Phase II Country Club Towers Apartment Complex
NW 68th Avenue and 186th Street Miami, Florida

general revision 02.17.05	
general revision 01.31.05	
general revision 01.06.04	
city comments 12.11.03	
12.5.03	
11.03.03	
Revisions 8.25.03	
Revisions 8.7.03	
Date 5.15.03	
Job number 0302	
Sheet number

overall site plan

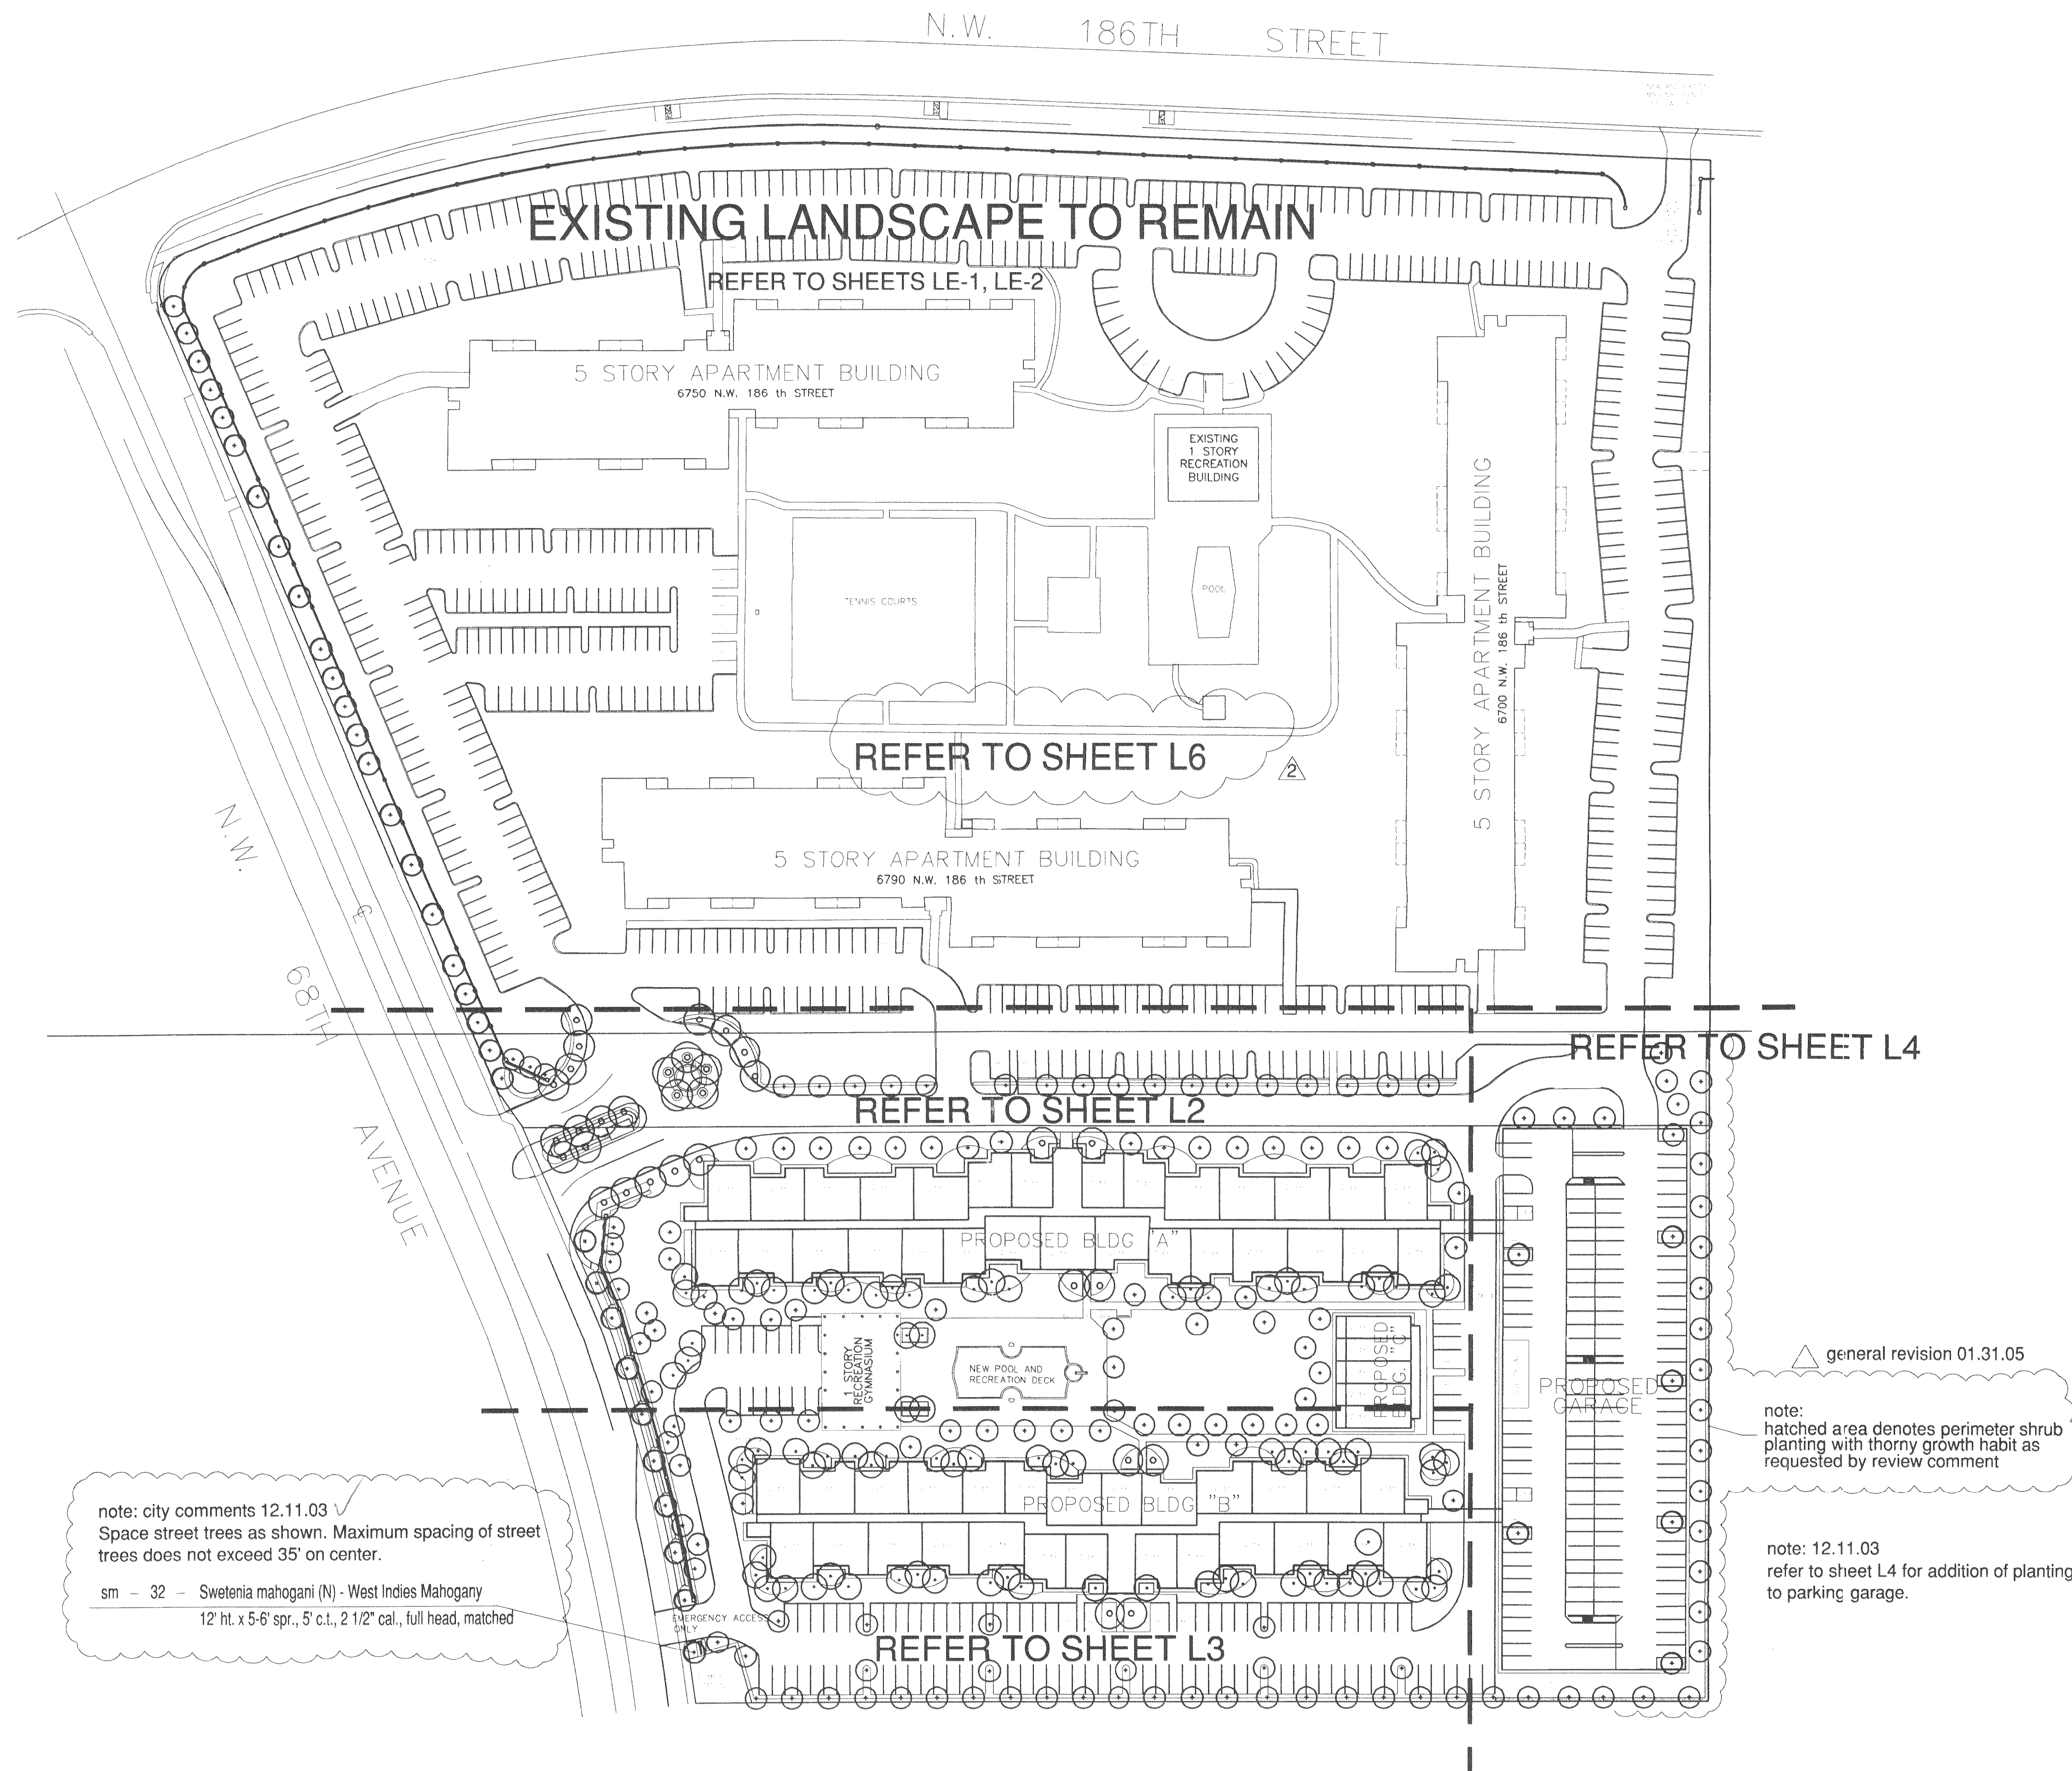
note: city comments 12.11.03
Space street trees as shown. Maximum spacing of street trees does not exceed 35' on center.

note: 12.11.03
refer to sheet L4 for addition of planting to parking garage.

note:
hatched area denotes perimeter shrub planting with thorny growth habit as requested by review comment

planting plan

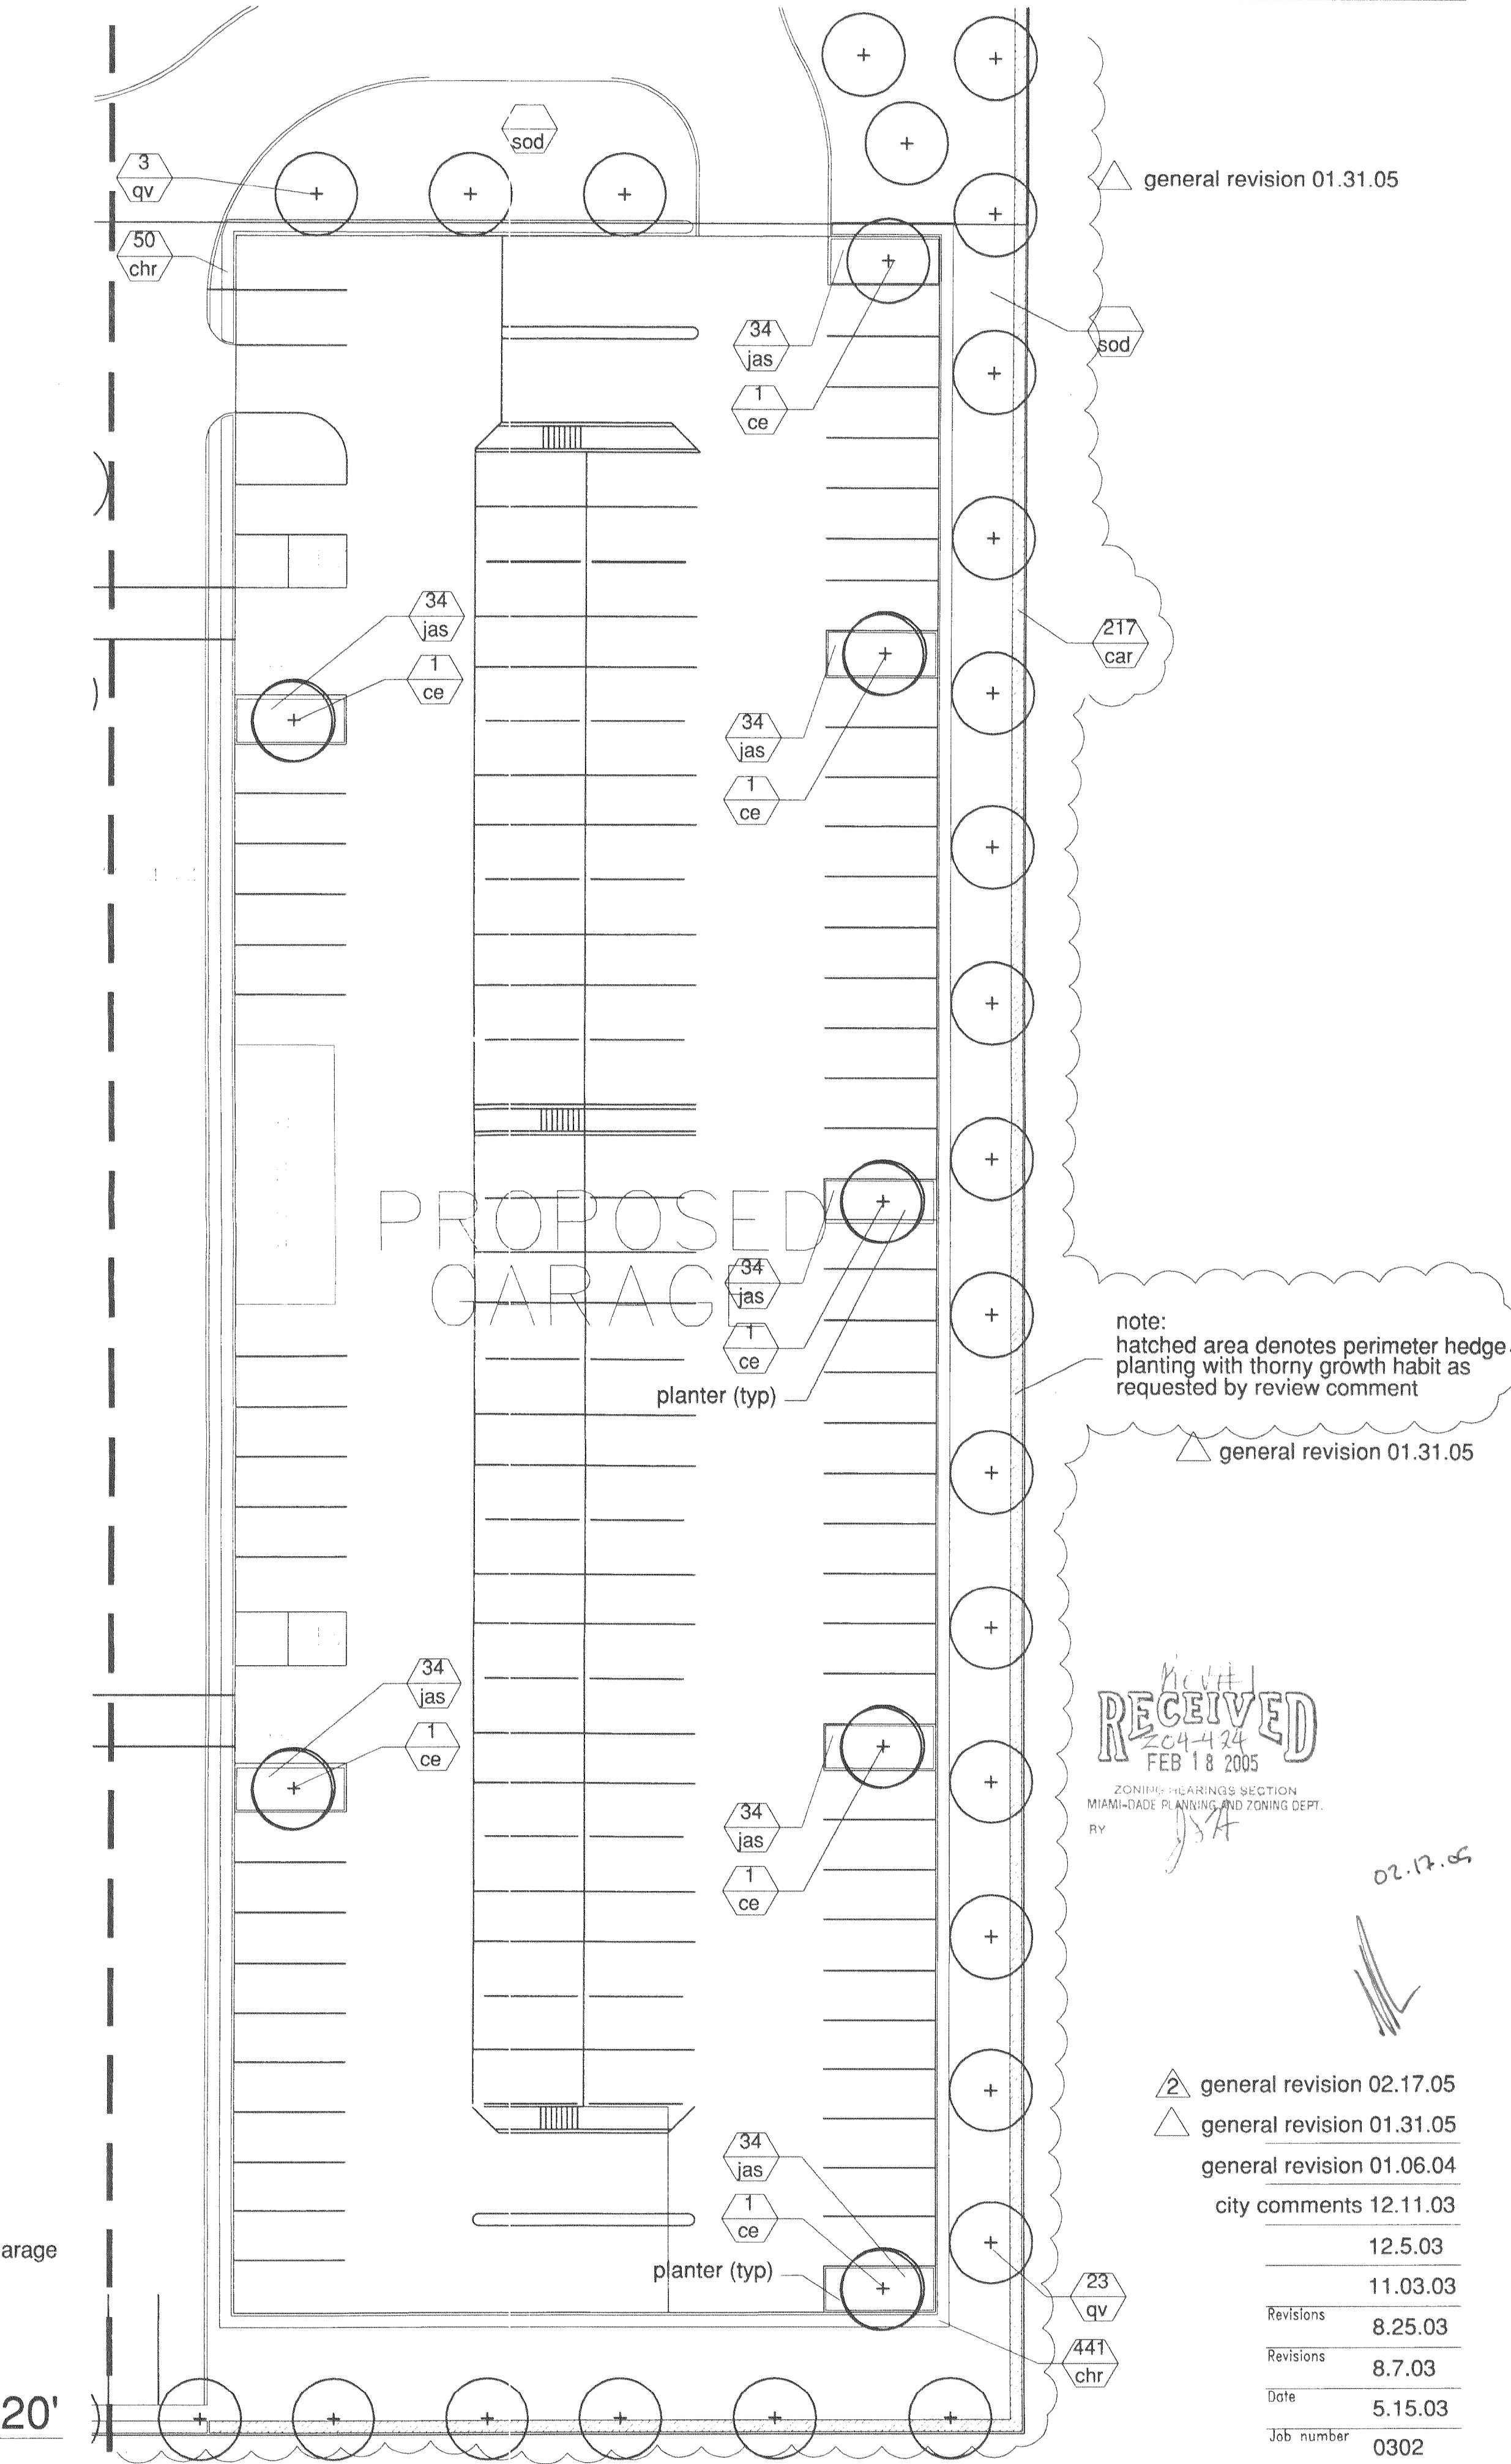
note: 12.11.03
addition of planters to garage
